UNITED STATES  
NUCLEAR REGULATORY COMMISSION  
WASHINGTON, D.C. 20555-0001

SUBJECT: CLASSIFICATION OF HANFORD LOW-ACTIVITY TANK WASTE FRACTION

**REPORT ON  
DOE HANFORD TANK WASTE CLASSIFICATION**

Figure 2-1. Estimate Hanford Site Tank Waste Radionuclide Inventory<sup>cd</sup>

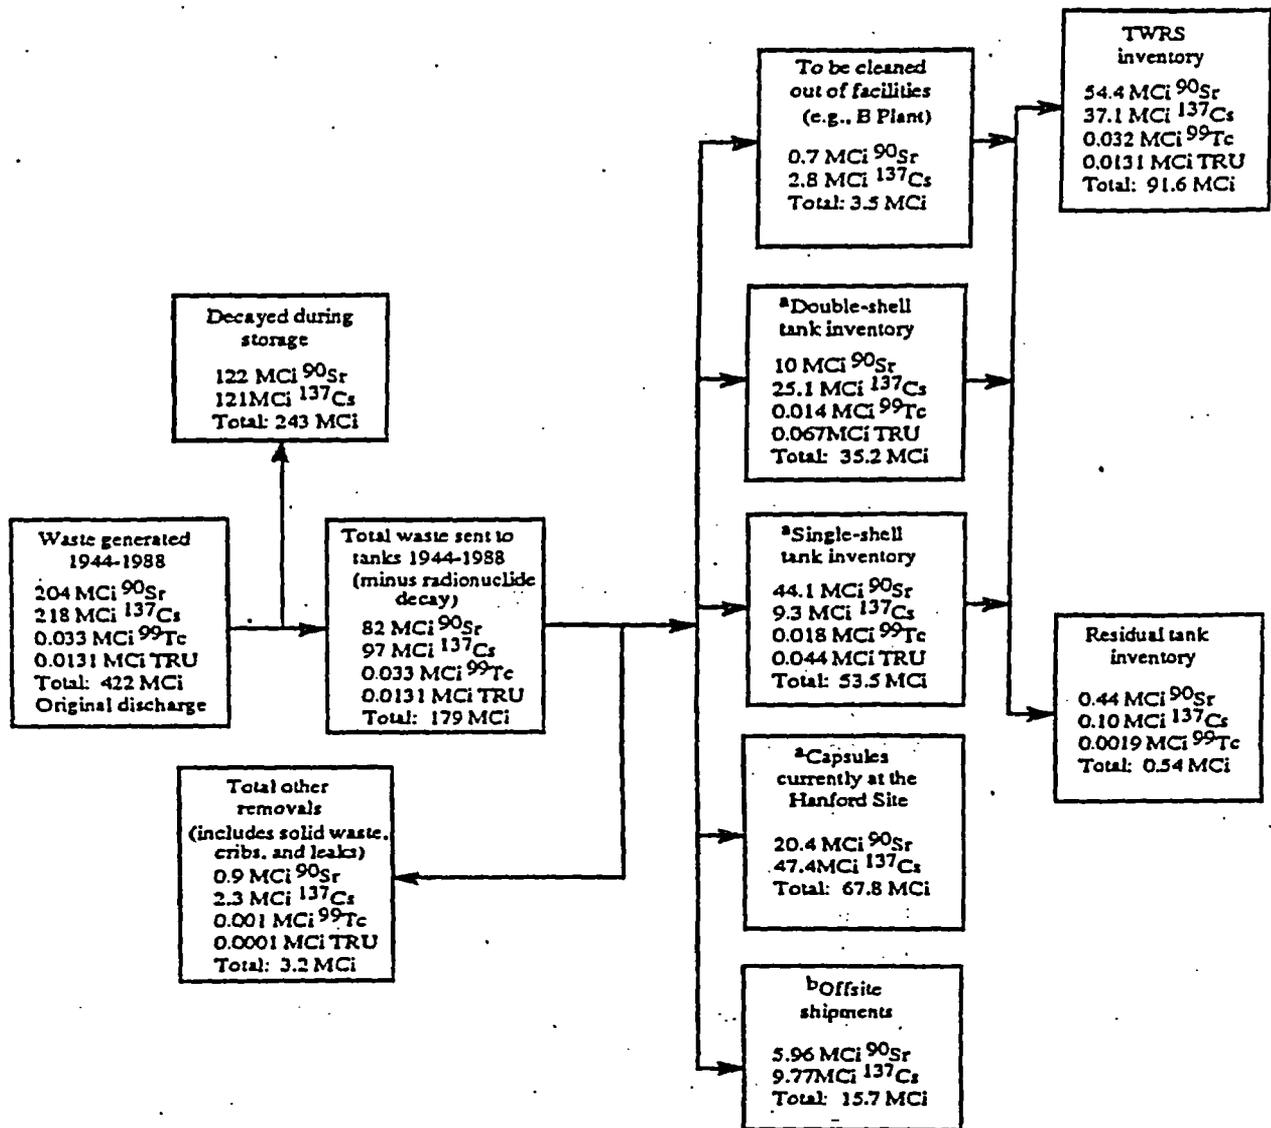
Figure 2-1, reproduced from the TBR (Westinghouse Hanford Company, 1996a, p. 3-2, figure 3-1), provides the estimated material balance for the Hanford Site tank waste radionuclide inventory. Figure 2-1 indicates that 243 MCi of the original tank waste radionuclide content of 422 MCi will have decayed by the year 1999. This value reflects the relatively short half lives of <sup>137</sup>Cs and <sup>90</sup>Sr. The material balance also indicates that approximately 87 MCi are accounted for as (i) leaks or deliberate discharges, (ii) encapsulation of <sup>137</sup>Cs and <sup>90</sup>Sr, (iii) other offsite shipments, or (iv) residual tank inventories. The remaining 91.6 MCi consists of 55.6 MCi insoluble waste to be disposed in a geologic repository as HLW and 36 MCi that comprises the soluble radionuclides that will be further treated to produce what DOE proposes to classify as incidental waste. This 36 MCi contains most of the <sup>137</sup>Cs and <sup>99</sup>Tc and almost all of the <sup>79</sup>Se, <sup>129</sup>I, <sup>14</sup>C, and <sup>3</sup>H (Westinghouse Hanford Company, 1996a, p. 4-1). After further treatment, 8.5 MCi will remain as incidental waste with 27.5 MCi being added to the HLW stream.

As shown in figure 2-1 of this report, 91.6 MCi comprises the Hanford Site tank waste inventory that will be processed for disposal as HLW or LLW. Approximately 99.9 percent of this waste is <sup>137</sup>Cs or <sup>90</sup>Sr. Initially, a simple solids-liquids separation will be performed on this waste to yield a low-activity liquid fraction containing the bulk of the nonradioactive materials, including about 3 percent solids carryover, and a high-activity fraction containing most of the solids. This solids-liquids separation process is expected to be relatively simple to complete and will remove approximately 55.6 MCi, consisting primarily of <sup>90</sup>Sr and TRU radionuclides (Westinghouse Hanford Company, 1996a, pp 3-2, 4-1, 4-2). Chapter 5 of the TBR concludes that, with the additional selective removal of transuranic wastes from three complexant concentrate tanks, and single-cycle ion exchange removal of <sup>137</sup>Cs from certain wastes,
